Z-10  
(2011)

ORIGINAL ISSUE DATE: 3/2/11
PROJECT NAME: PRELIMINARY SITE PLAN
SHEET TITLE: 4
SHEET NUMBER: 4

APPLICANT: QuickTrip Corporation

**ZONING COMMENTS:**

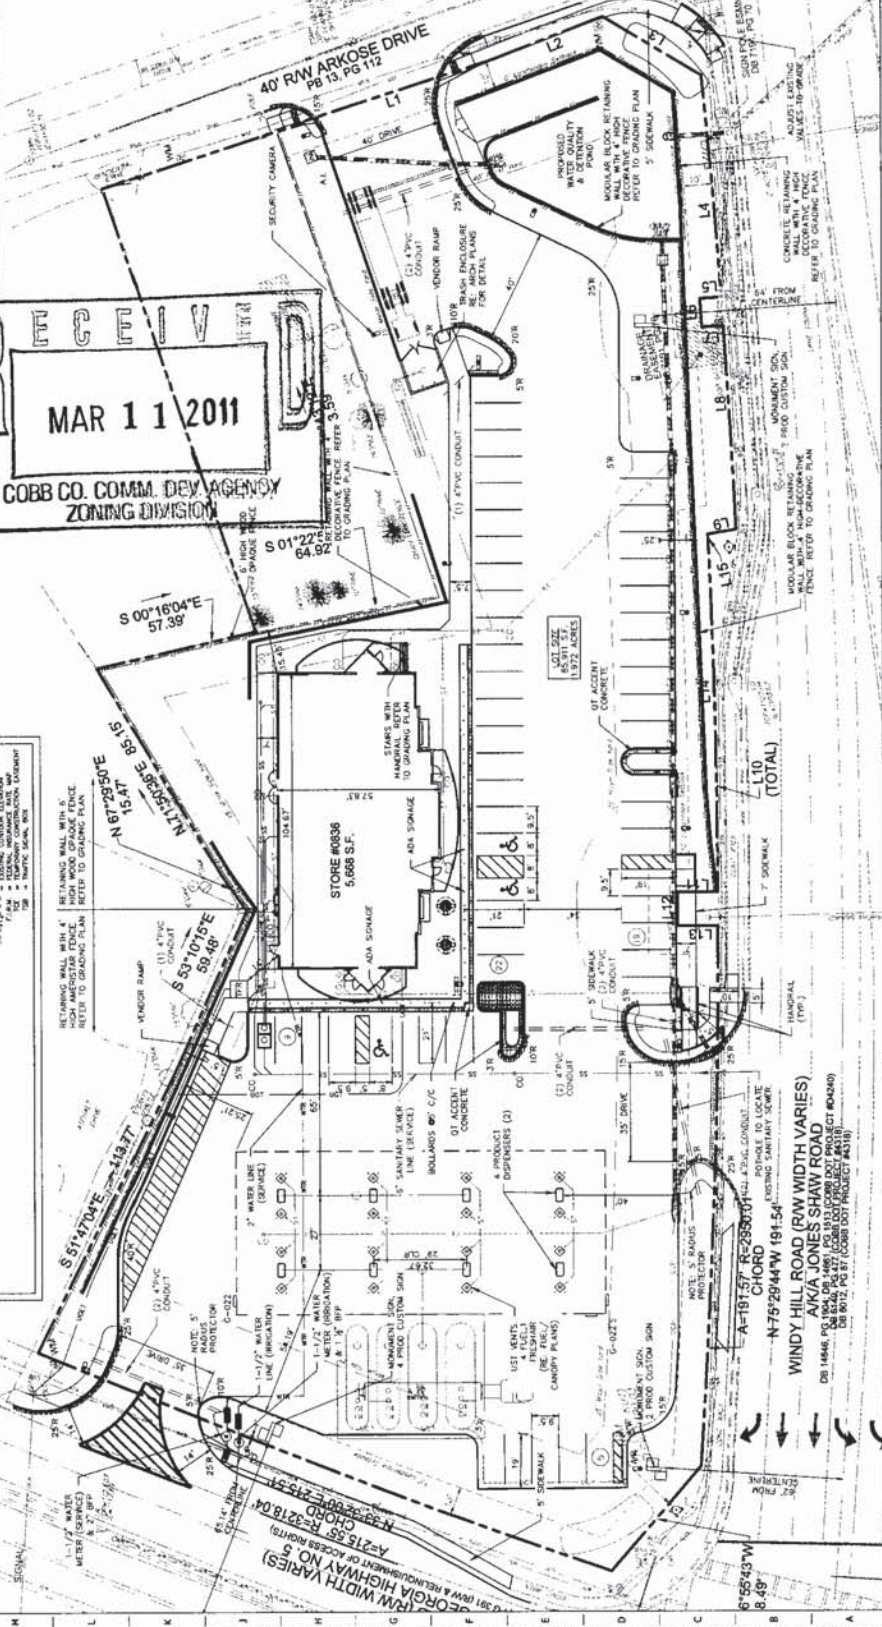
**Development & Inspections:** Proposed parking lot does not comply with County Tree Ordinance. Insufficient number of parking lot peninsulas provided.

- Provide comprehensive hydrology/stormwater controls to include development of out parcels.
Submit all proposed site improvements to Plan Review.
Any spring activity uncovered must be addressed by a qualified geotechnical engineer (PE).
Structural fill must be placed under the direction of a qualified registered Georgia geotechnical engineer (PE).
Existing facility.
Project must comply with the Water Quality requirements of the CWA-NPDES-NPS Permit and County Water Quality Ordinance.
Water Quality/Quantity contributions of the existing lake/pond on site must be continued as baseline conditions into proposed project.
Calculate and provide % impervious of project site.
Revisit design; reduce pavement area to reduce runoff and pollution.

- No Stormwater controls shown
Copy of survey is not current - Additional comments may be forthcoming when current site conditions are exposed.
No site improvements showing on exhibit.

- The site discharge will be tied directly into the existing drainage system within the Windy Hill Road right-of-way. The existing system is limited by the capacity of the existing 18-inch RCP culvert under Windy Hill Road. The detention pond and stormwater management design must account for the existing downstream system capacity.
The water quality best management practice design must provide for oil/water separation since this site will have a fueling center.

Windy Hill Road is classified as an arterial and according to the available information the existing right-of-way does not meet the minimum requirements for this classification. Recommend applicant consider entering into a development agreement pursuant of O.C.G.A. 36-71-13 for dedication of the following system improvements to mitigate traffic concerns: a) donation of right-of-way on the north side of Windy Hill Road, a minimum of 50' from the roadway centerline.

Arkose Drive is classified as a local and according to the available information the existing right-of-way does not meet the minimum requirements for this classification. Recommend applicant consider entering into a development agreement pursuant of O.C.G.A. 36-71-13 for dedication of the following system improvements to mitigate traffic concerns: a) donation of right-of-way on the west side of Arkose Drive, a minimum of 25' from the roadway centerline.

Recommend installing curb, gutter, and sidewalk along the Arkose Drive road frontage.

Recommend the access on Arkose Drive to be a right-in/right-out and left in driveway.

- Site plan received by Zoning Division on March 11, 2011 in regards to store size and building setbacks;
- A landscape plan to be submitted and approved by County Arborist during the Plan Review process in order to acceptably screen property from neighboring residences (District Commissioner shall have final approval of said plan);
- Water and Sewer comments and recommendations;
- Stormwater Management comments and recommendations;
- DOT comments and recommendations; and
- Owner/developer to enter into a Development Agreement pursuant to O.C.G.A. §36-71-13 for dedication of system improvements to mitigate traffic concerns.
